**FINAL  
ENVIRONMENTAL IMPACT REPORT  
FOR THE  
LOWER MOOSA CANYON WATER  
RECLAMATION FACILITY EXPANSION  
(SCH# 95121009; MUP# P73-18W<sup>1</sup>)**

**VOLUME I**

July 1996

Figure 6

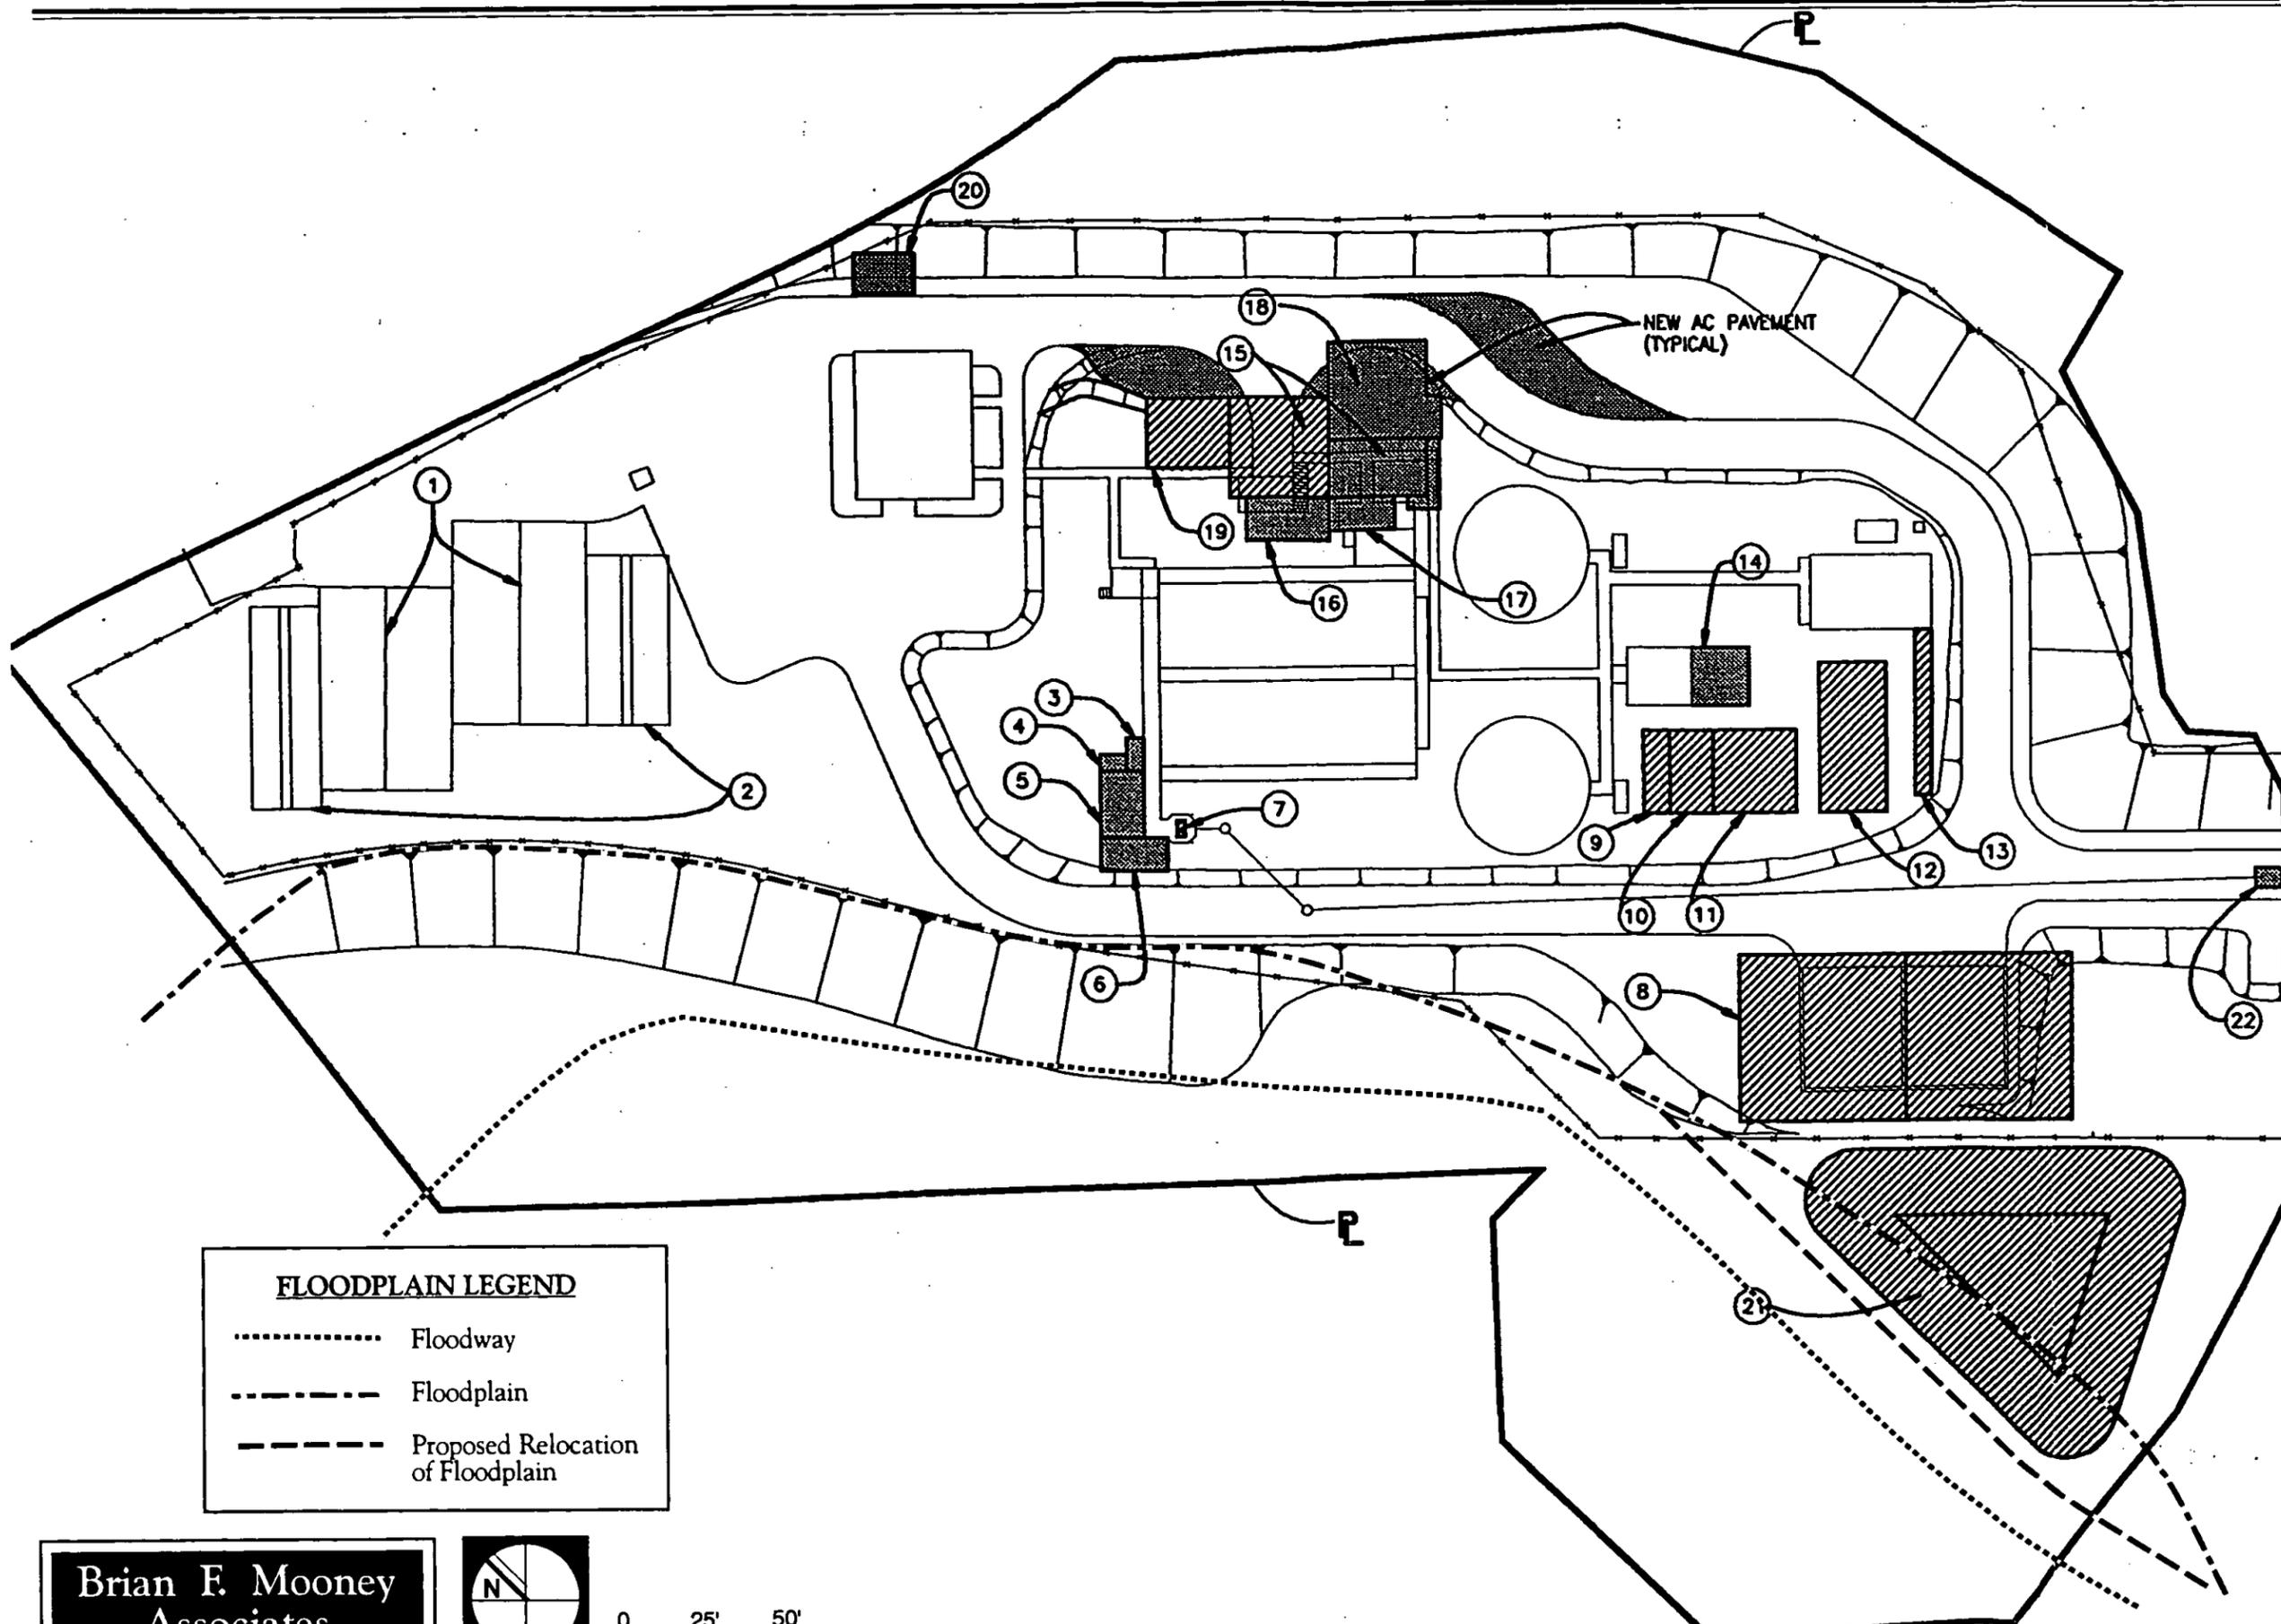
1. As stated in the Hydrology section of the Draft EIR, final engineering plans shall provide the location of the mapped floodplain and floodway in relation to the location of the flow equalization basin and the forebay. If it is not possible to identify the exact location of the floodplain and floodway at this time, the EIR needs to identify that the project will be responsible for completing appropriate revisions to existing County and FEMA mapping once the locations of the floodway and floodplain are known.
2. Figure 6 on page 47, and the text in the second paragraph of page 52 and the second paragraph on page S-3 do not agree as to the location of the forebay in relation to the existing Floodway of Moosa Creek. Please revise.

Response: Figure 6 is based on the floodway location as provided on current County and FEMA maps and plot plan design of the forebay. This figure does not illustrate any slope to be graded for installation of the forebay. Figure 5 included under the biological resources discussion shows some preliminary engineering design and the toe of the graded slope approximately colinear with the floodway. As indicated in Figure 5, the project would be out of the floodway but at this level of information accuracy some minor earthwork may or may not actually occur within the floodway. Under the EIR process, impacts are therefore appropriately found as significant and mitigation measures identified to reduce impacts as warranted. The Summary is revised on page S-3 to reflect more precisely the main text finding. For clarification the term "100 -flood zone" on page 53 has been changed to "100-year floodplain".

Figure 8  
Vantage Point Locations

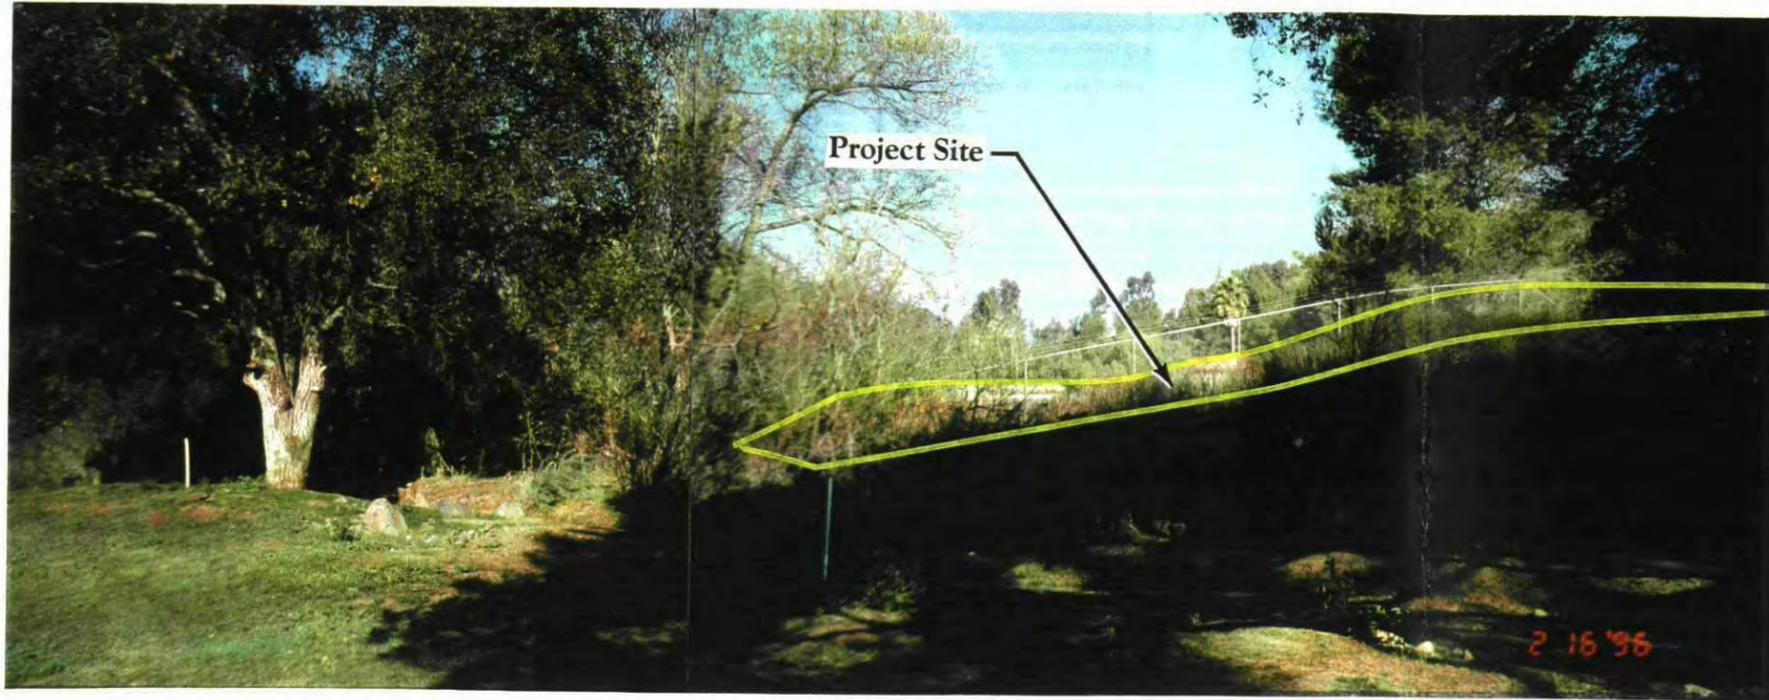
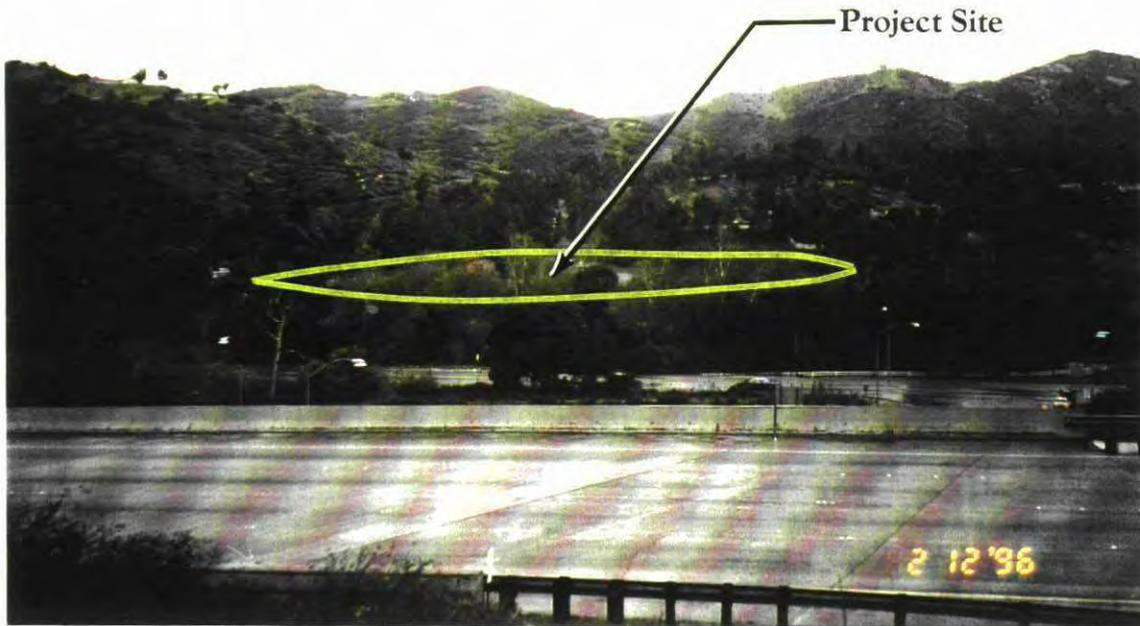
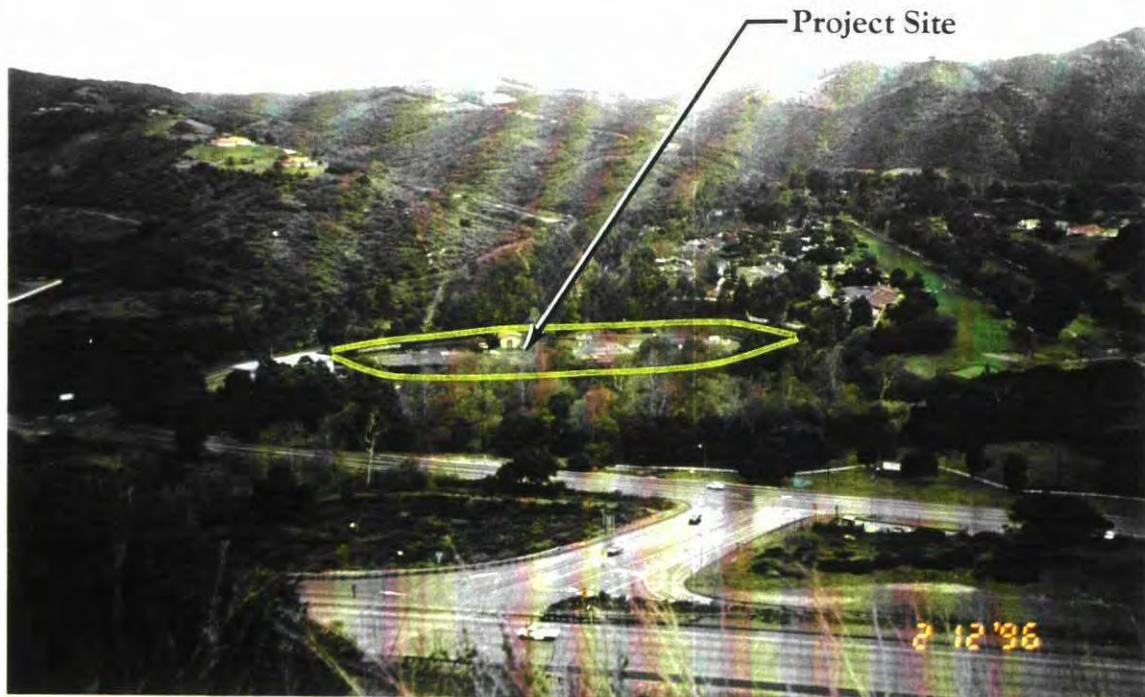
Exception is taken to the following statement on page 73 of the Draft E.I.R., "The site is well screened by existing landscaping, fencing and topography." Pictures do not tell the whole story, to the naked eye the plant is visible from Vantage Point 2 (Figure 9) and will be much more visible after the proposed new construction. Vantage Point 1 (Figure 9), which is where houses are located, views a large exposed area of the existing plant. There is no photo from the sidewalk along Circle R Drive (Northern border of the plant) where the plant is thoroughly exposed to walkers and vehicle passengers.
